- 12. Sleepy Hollow Longmere Landing Addition
KPB File 2021-003R1**

ITEM 12 – SLEEPY HOLLOW SUBDIVISION LONGMERE LANDING ADDITION

KPB File No.	2021-003R1
Plat Committee Meeting:	November 14, 2022
Applicant / Owner:	Estate of Kent Bangerter of Salt Lake City, UT
Surveyor:	John Segesser / Segesser Surveys
General Location:	Walton Way, Longmere Lake, Sterling

STAFF REPORT

Sleepy Hollow Subdivision Longmere Landing Addition

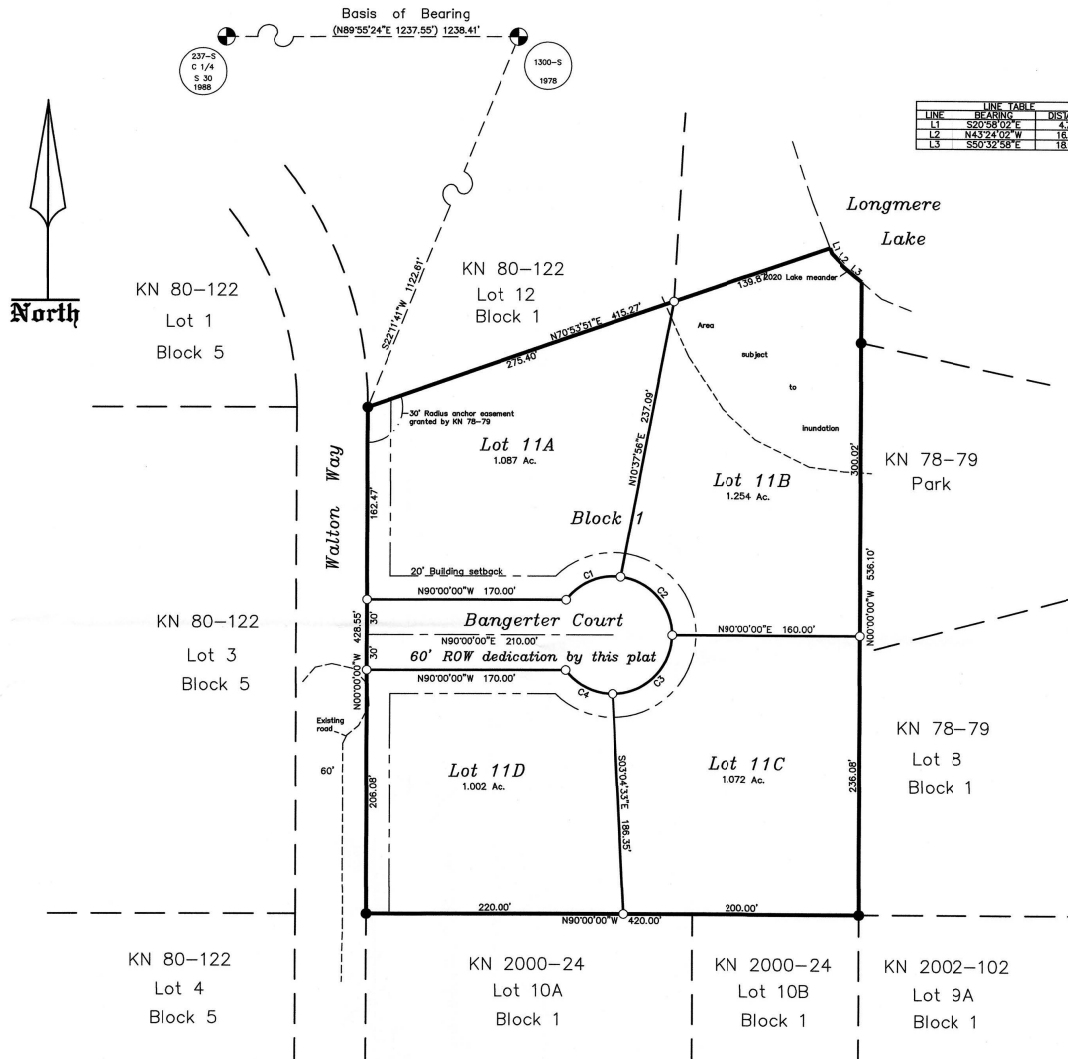
- Staff recommendation:** *The ownership must be verified and match the certificate to plat. Unless additional deeds are recorded the ownership will be the owner's estate.*

- Staff recommendation:** *There is a duplicate section label. Township label is required.*

Staff recommendation: *The lots to the southeast of the subdivision have been replatted and need new labels and depiction.*

Staff recommendation: *Add measured and recorded data to final.*

- *Add the code to plat note 3, "(KPB 14.06)".*

- Update the code listed in plat note 6, KPB 20.60.170.
- Plat notes for any additional easements that have been granted per the Certificate to Plat

Staff recommendation: *The certificate should be updated to be on behalf of the estate and the signature line updated to personal representative on behalf of the estate unless ownership has changed. Comply with 20.60.190.*

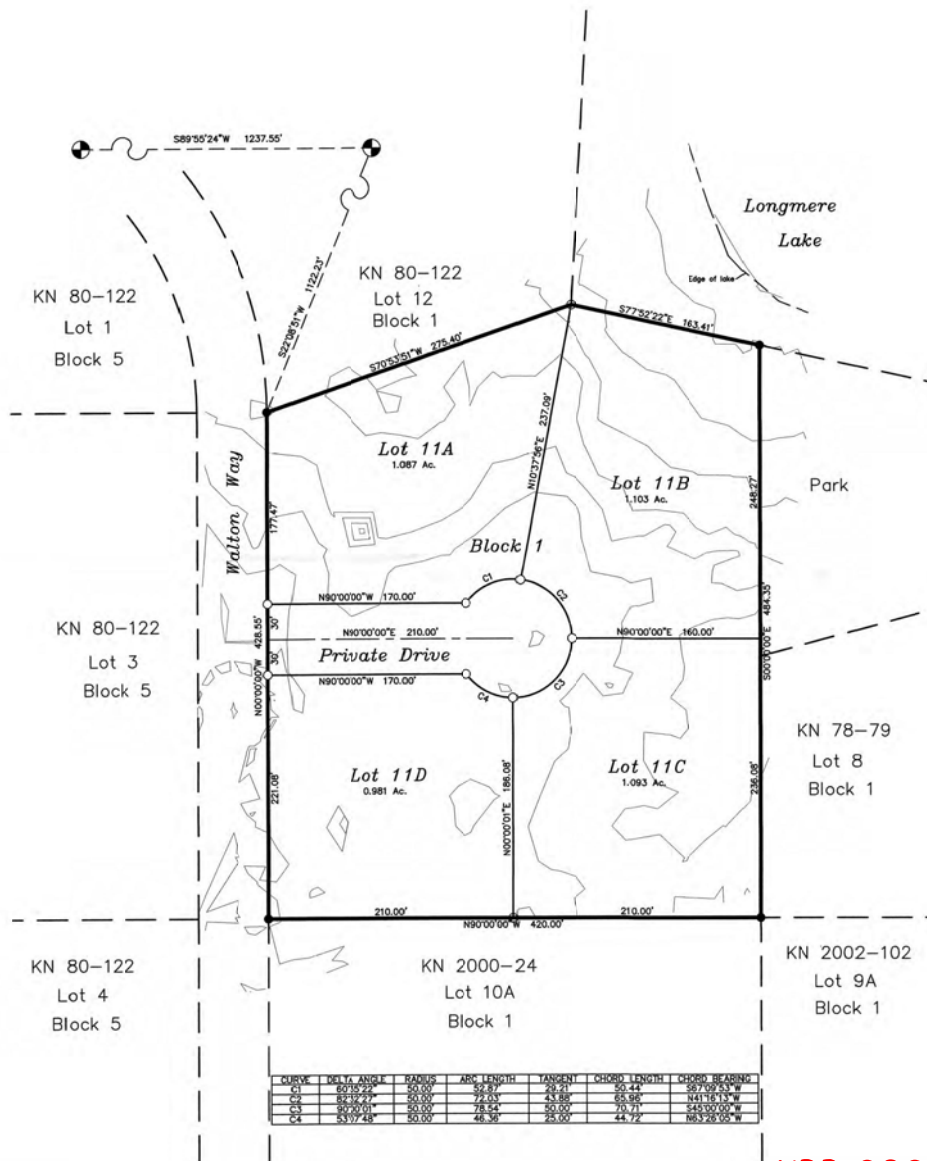
- C. The location, width, and name of existing or platted streets and public ways, railroad rights-of-way, and other important features such as section lines or political subdivisions or municipal corporation boundaries abutting the subdivision;
Staff recommendation: *Add the road width label for Walton Way.*

- D. A vicinity map, drawn to scale showing location of proposed subdivision, north arrow if different from plat orientation, township and range, section lines, roads, political boundaries, and prominent natural and manmade features, such as shorelines or streams;
Platting Staff Comments: *There is a line through sections 9, 8, 7, 18, 13, 24 that shall be labeled or removed. The Township and Range need to be added to the map.*
Staff recommendation: *Label or remove additional lines and add the township and range labels.*

- G. Status of adjacent lands, including names of subdivisions, lot lines, block numbers, lot numbers, rights-of-way; or an indication that the adjacent land is not subdivided;
Platting Staff Comments: The lot labeled "Park" should have the recording number listed, KN 78-79. The lot line depiction of Lot 10A to the south is in the incorrect location. Plat KN 2000-24 moved the lots lines and Lot 10A is not in line with the eastern boundary of the subdivision.
Staff recommendation: Update the label for the park and show the correct lot line placement for Lot 10A.

- M. Approximate locations of slopes over 20 percent in grade and if contours are shown, the areas of the contours that exceed 20 percent grade shall be clearly labeled as such;
Platting Staff Comments: The contours shown on the plat do not match KPB GIS data. KPB GIS data does not show any steep slopes. Using the lines presented it does not appear that there are slopes exceeding 20 percent.
Staff recommendation: Final plat can remove the contours but should depict any steep slopes or top/toe of bluffs.

Platting Staff Comments: The design of the private road complies. An additional turn around area needs to be provided where the private drive meets Walton Way. This may be another bulb with a 50 foot radius or a hammerhead or T-type turnaround. This area will provide for an adequate around for delivery, service, or emergency vehicles who are denied entry past the gate to be able to turn around. The turnaround area will lead directly to the private road. Where the turnaround area ends and the private road begins a gate may be installed.

Staff recommendation: *Provide adequate turn around area to comply with the private street standards.*

Staff recommendation: *Determine, and depict, the current meander line of Longmere Lake. If necessary, update the acreage of the parent parcel in the title block as well as Lot 11B. Provide a plat note that reads, 'The natural meanders of ordinary high water (or mean high water line as applicable) is for area computations only, the true corners being on the extension of the sidelines and the intersection with the natural meanders.' Comply with 20.60.110.*

Platting Staff Comments: The boundary is correct but does have strike through on several of the survey marker symbols.

Staff recommendation: *Correct the boundary so symbols do not have any strike through.*
